**Assessment of the Influence
of Dewatering at Bailly N-1**

D'APPOLONIA

Project No. MW79-720
November, 1980

FIGURE 9 REPRODUCED
FROM USGS REPORT 78-138

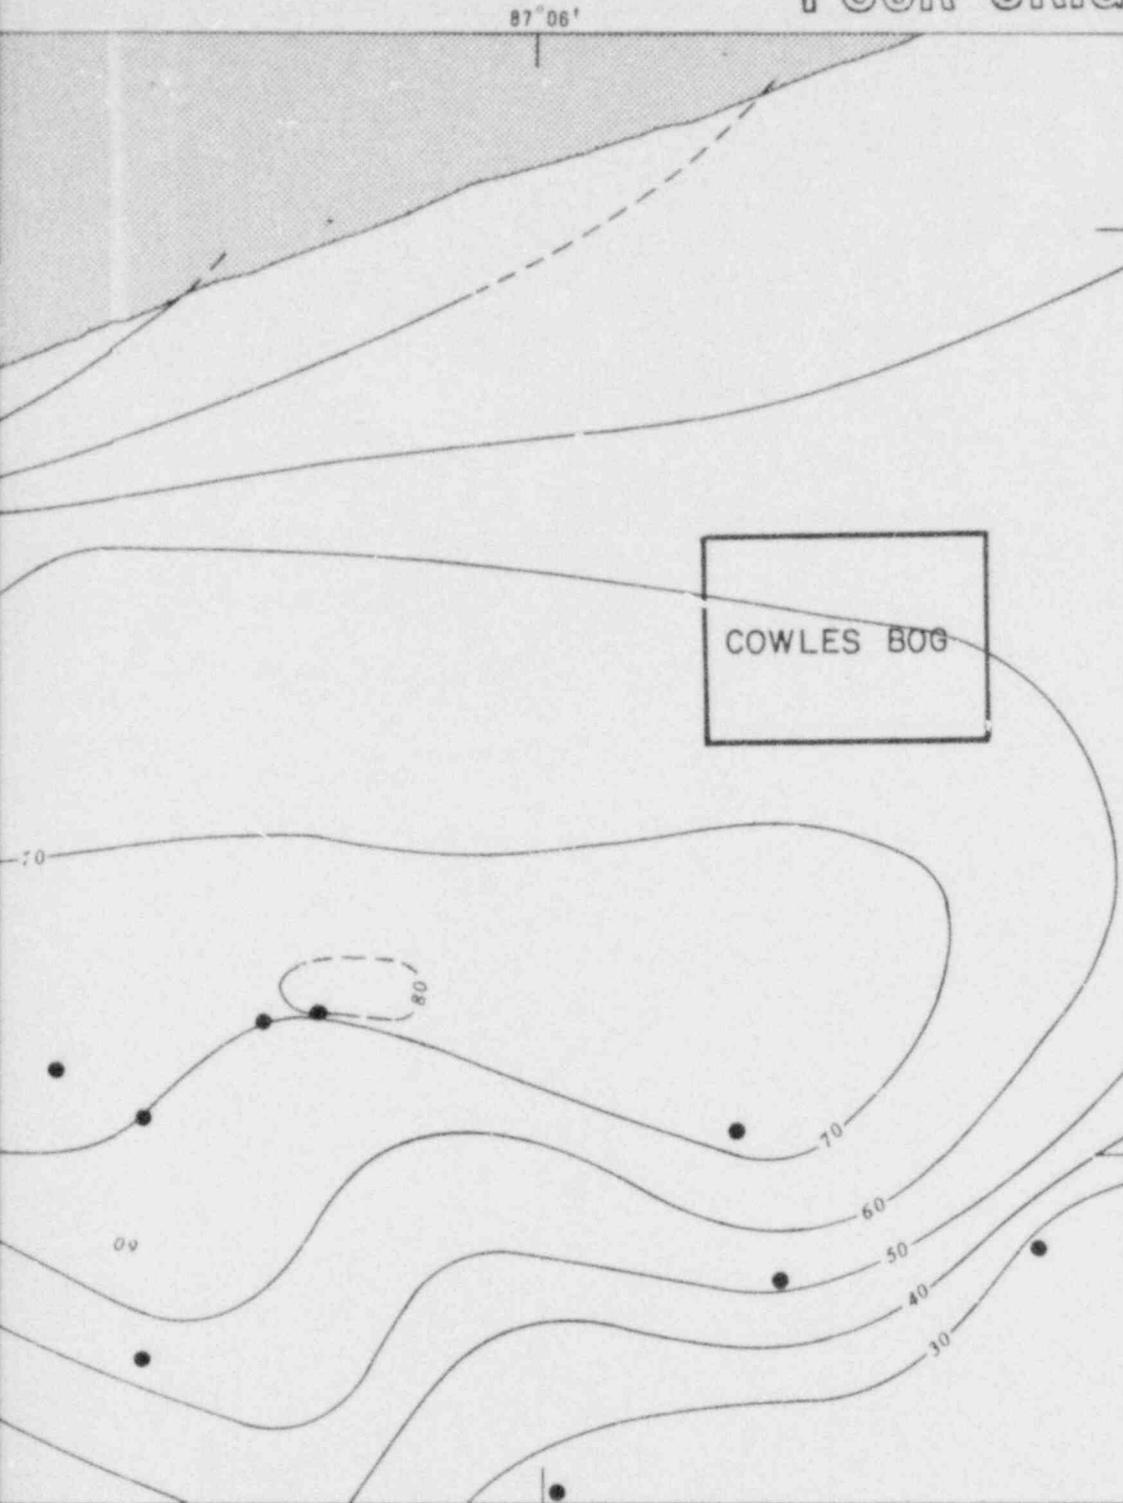
In the 5000 by 8000 foot area between NIPSCO's east property line and Cowles Bog, no boring has been drilled deep enough to determine the thickness of Unit 3. Accordingly, Figure 9 showing "thickness of unit 3" in that area is speculative. This figure is included in Appendix B.

FIGURE 11 REPRODUCED
 FROM USGS REPORT 78-138

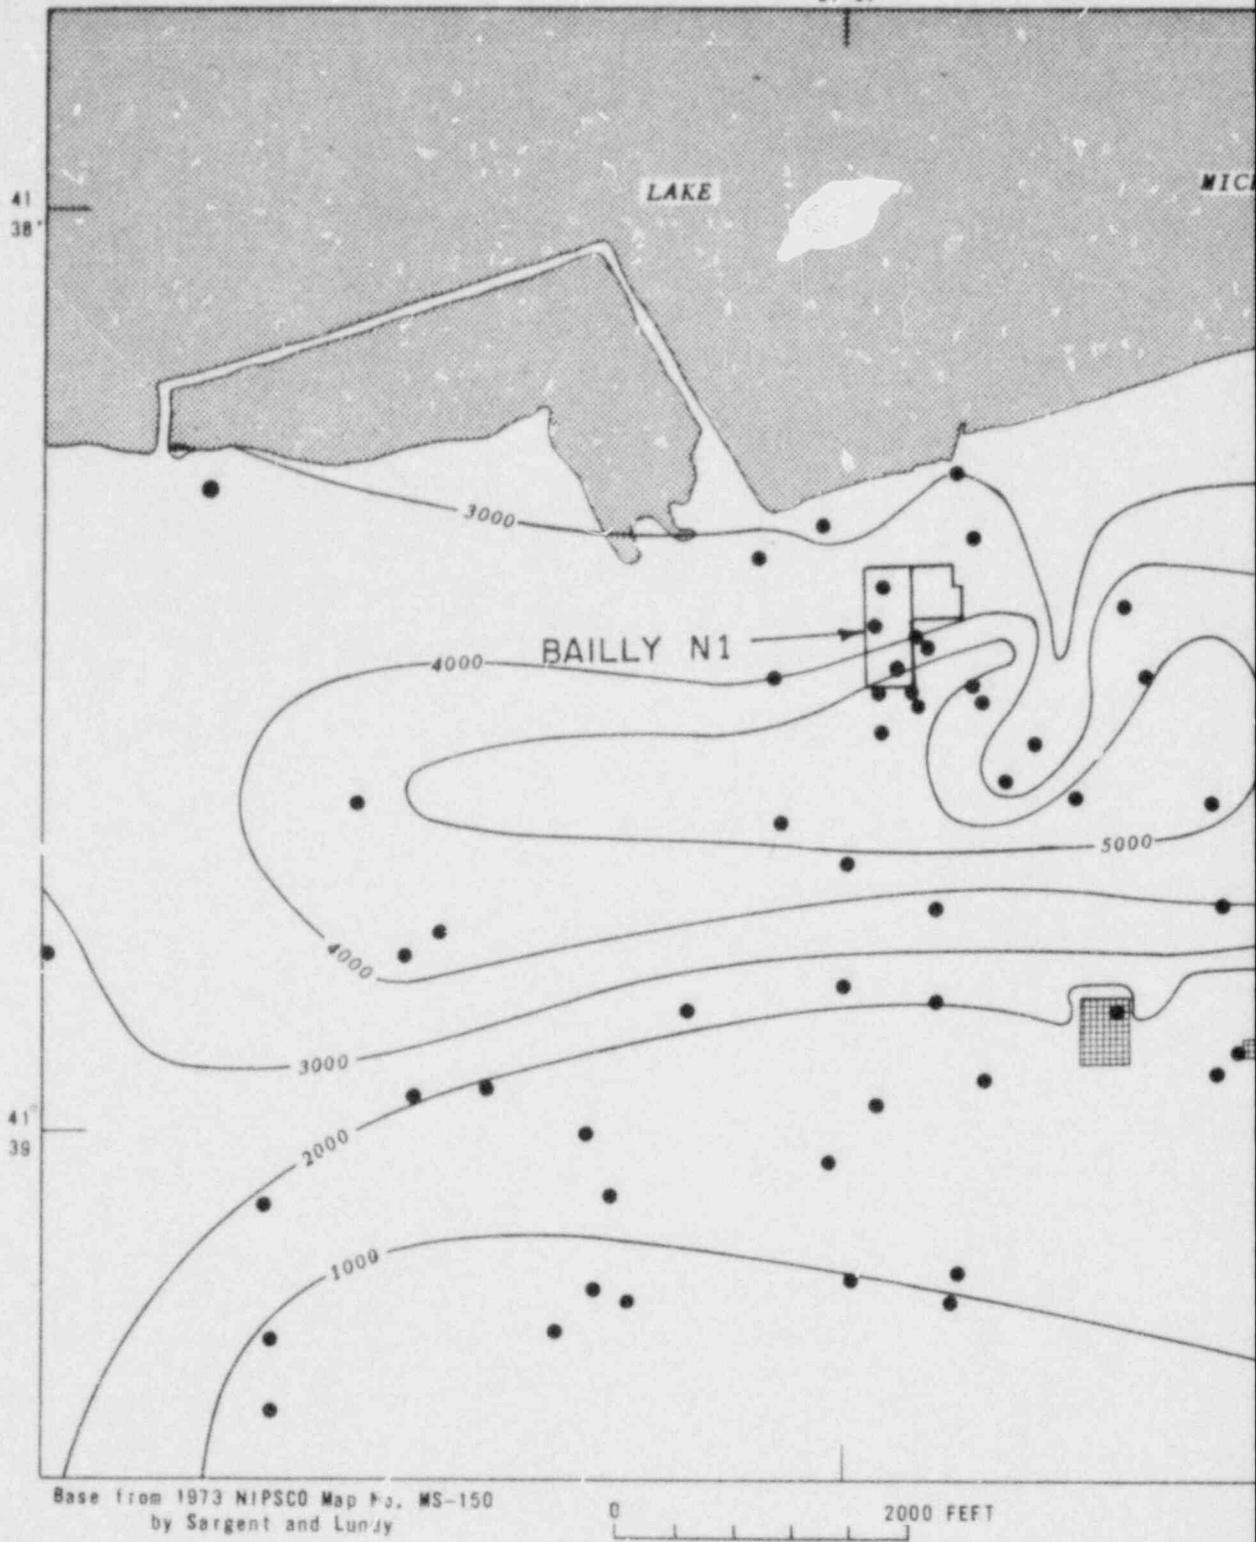
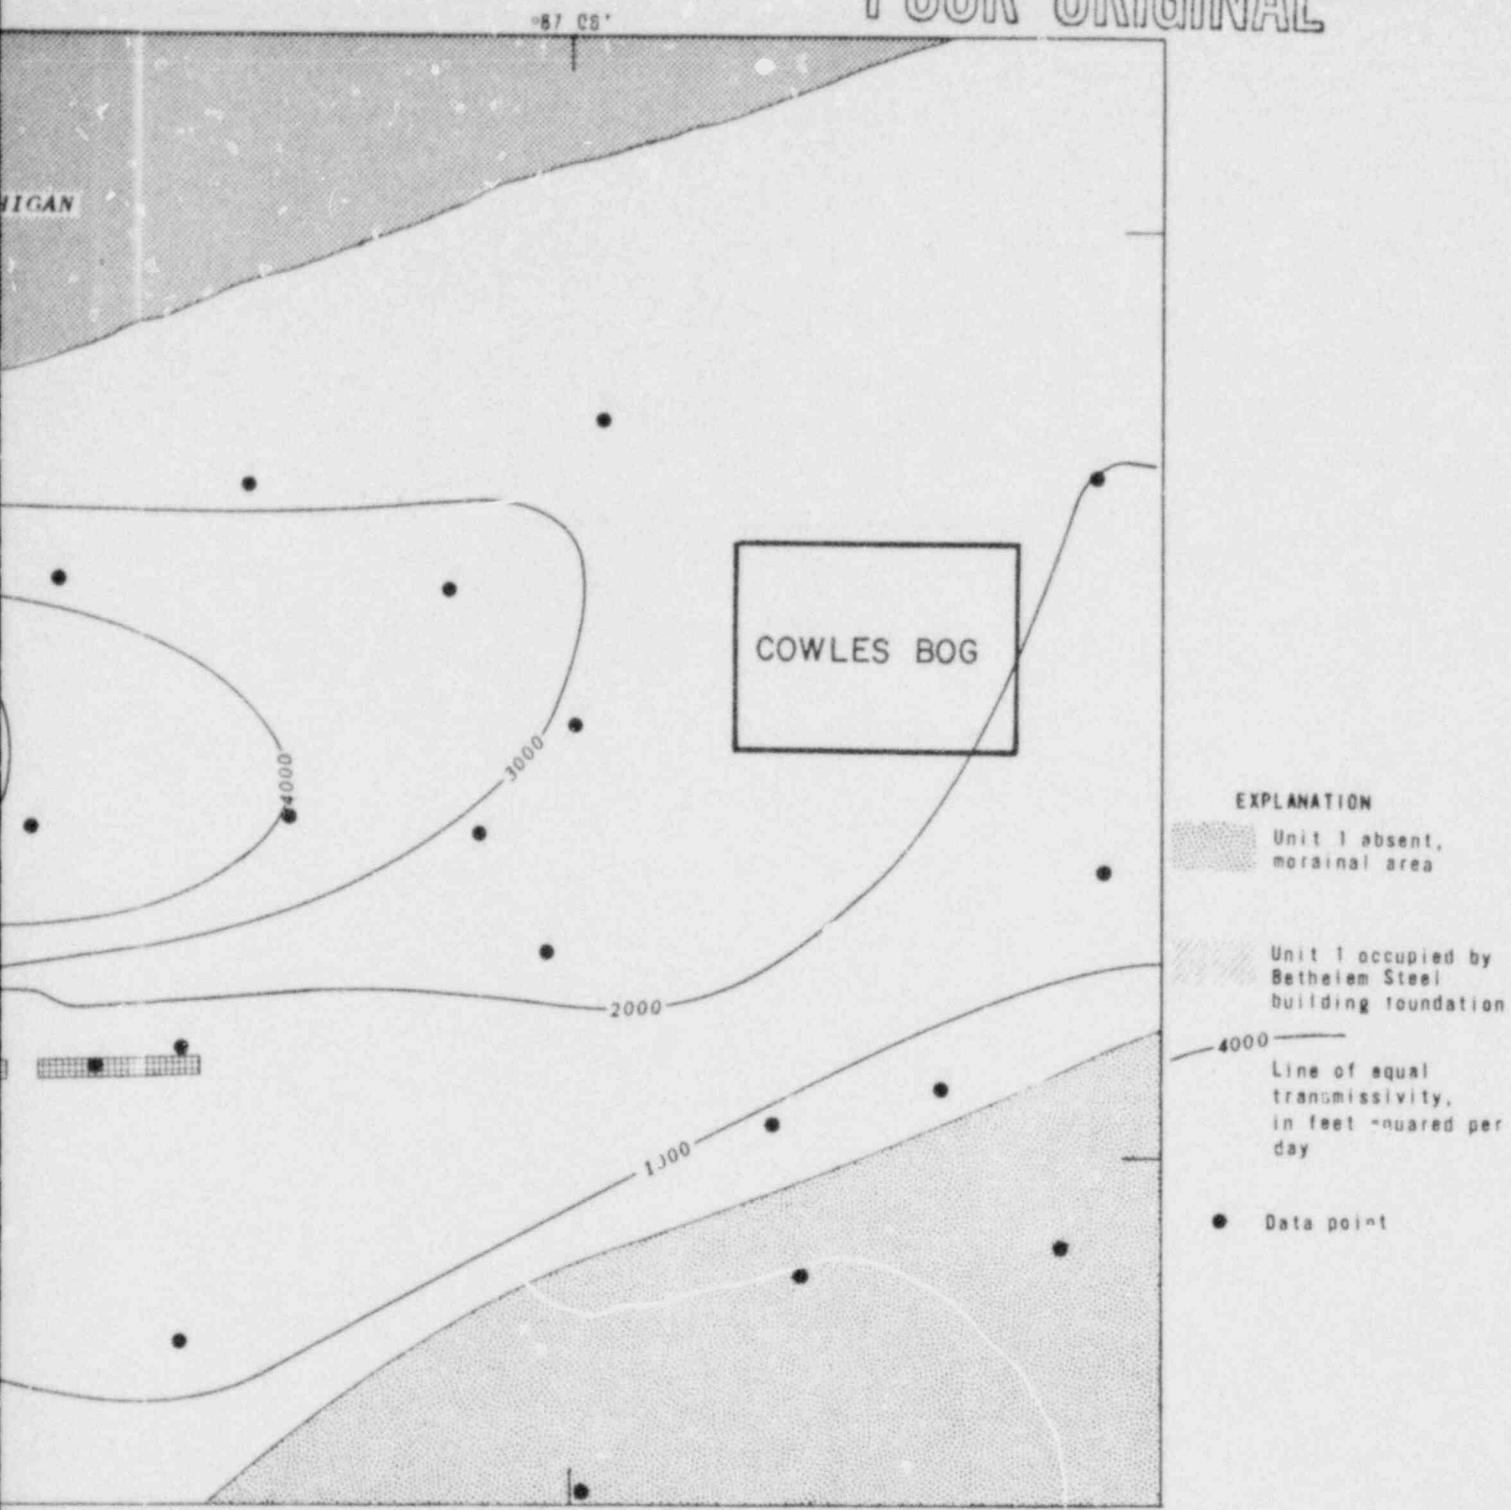
Figure 11 (Reference 1) is included in Appendix B and shows that Unit 1 is absent in the southeast corner of the study area.

Figures 13 and 25 (Reference 1) then show groundwater levels for Unit 1 in the area where Unit 1 is supposedly absent. Obviously this is incorrect (Figure 5 of this report).

FIGURE 12 REPRODUCED
FROM USGS REPORT 78-138

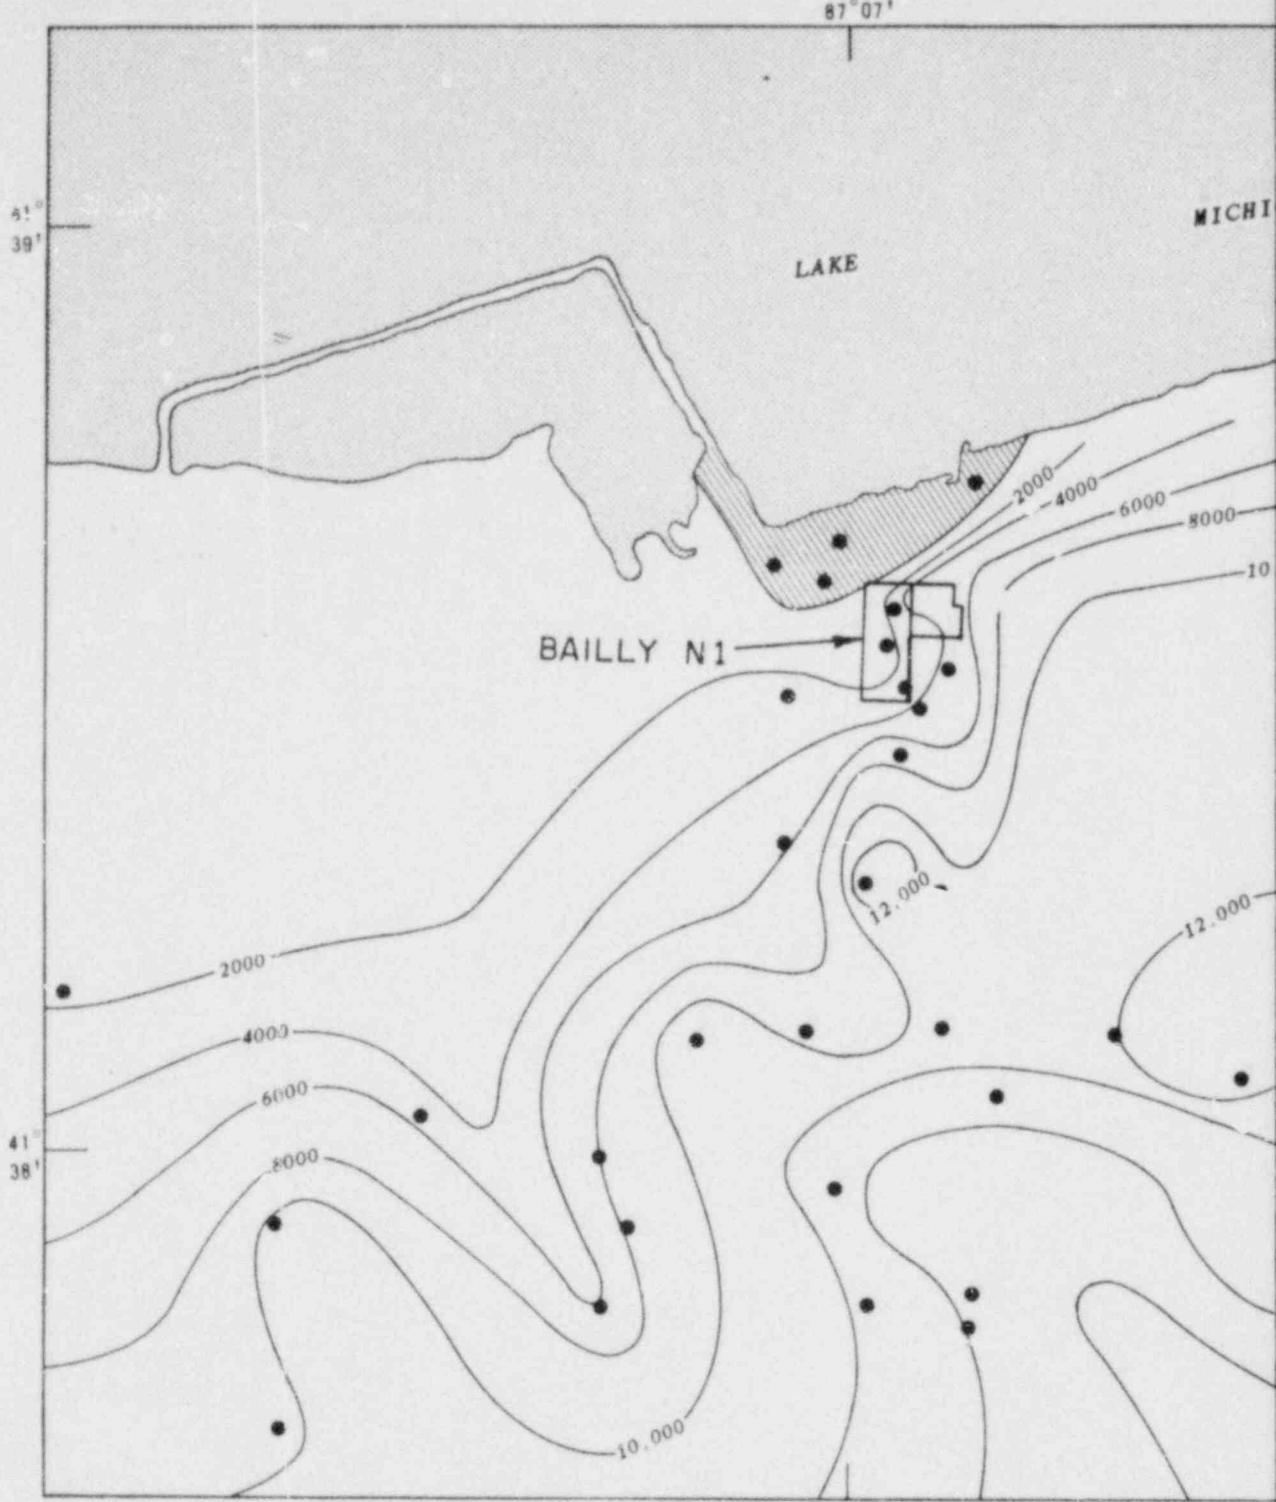
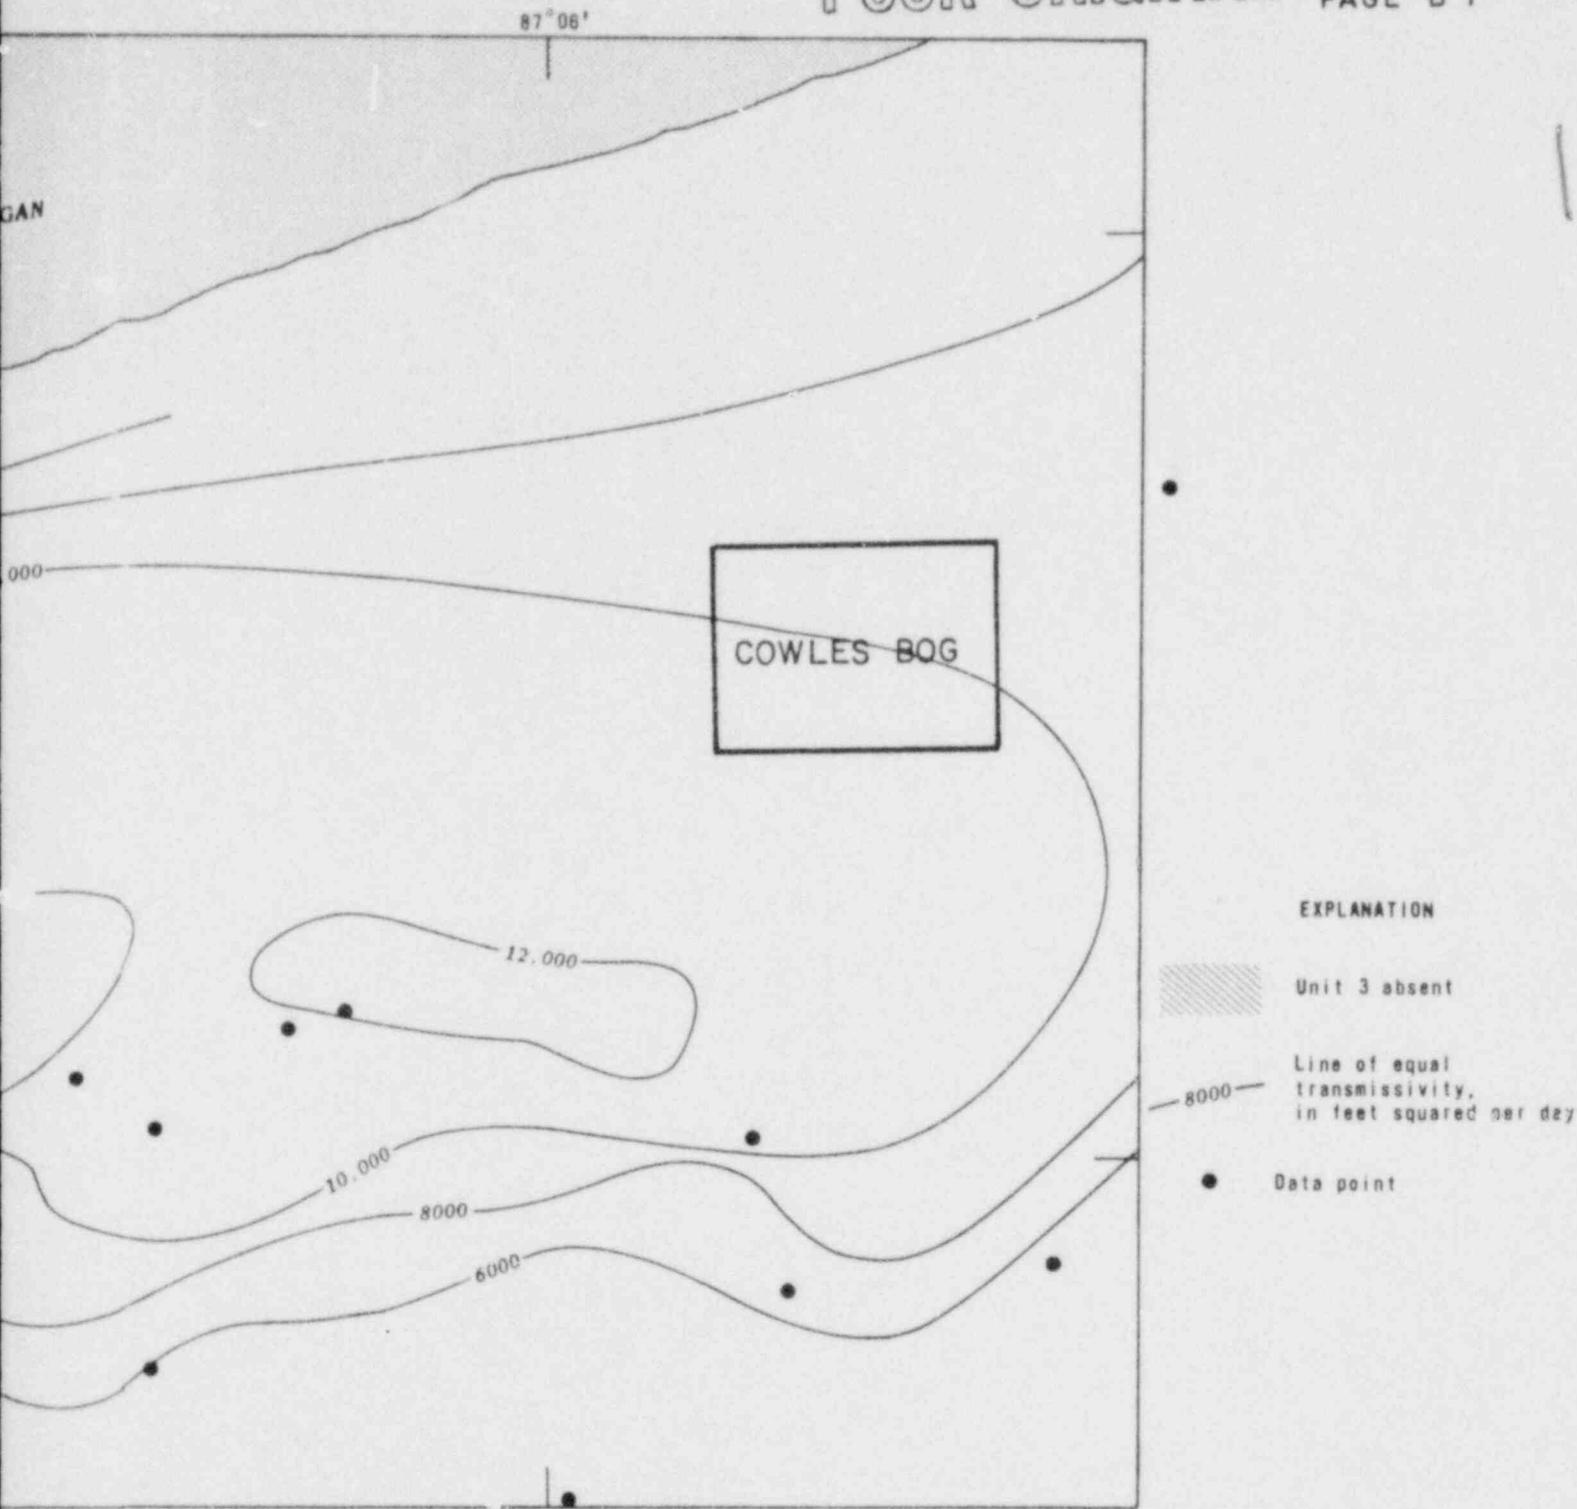
Because the coefficients of permeability used by the authors are incorrect and the absence of information from deep borings in the area between NIPSCO's east property line and Cowles Bog, the estimate of transmissivity as shown in Figures 11 and 12 (Reference 1) is invalid. Any transmissivity lines drawn between NIPSCO's east property line and Cowles Bog are speculative. Figures 11 and 12 from Reference 1 are included in Appendix B.
